# Comments on Receiver Jitter Tolerance Specs

**40Gb/s Ethernet Single-mode Fibre PMD Task Force  
Geneva, May 2010**

# Two jitter tolerance specs are being proposed by task force

## Telecom type jitter tolerance with 1dB optical power penalty method at BER = 1E-10

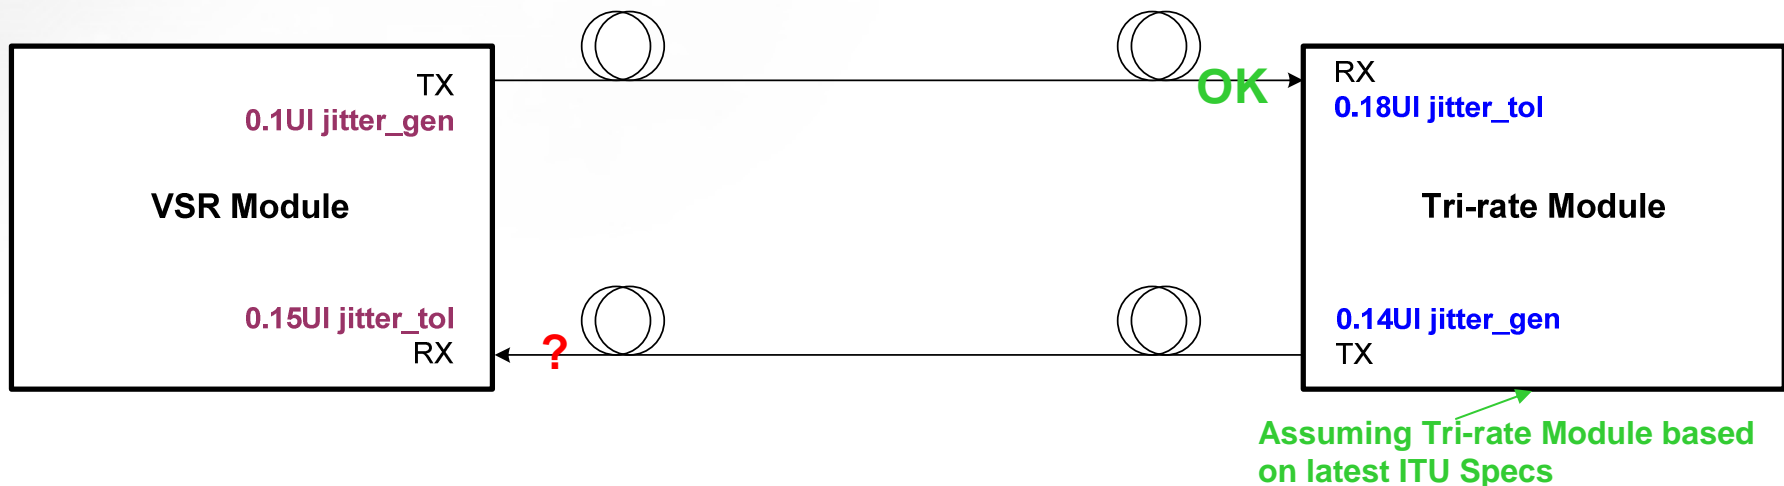
❑ We support the telecom like jitter tolerance as shown in Table 87-14:

1. Simplified testing w/o complication of SRS
2. Consistent spec across tri-rates

❑ But we have concern about the spec at frequency above 16MHz w/o reference to jitter generation

1. Support “telecom like” jitter tolerance spec similar to Table 89-14
2. Add informative spec of jitter generation 0.1 UI over 16MHz – 10x LB to guarantee backward compatible to legacy VSR module
3. Specify jitter tolerance 0.15UI at frequency above 16MHz, which is sufficient with a 0.1UI jitter generation
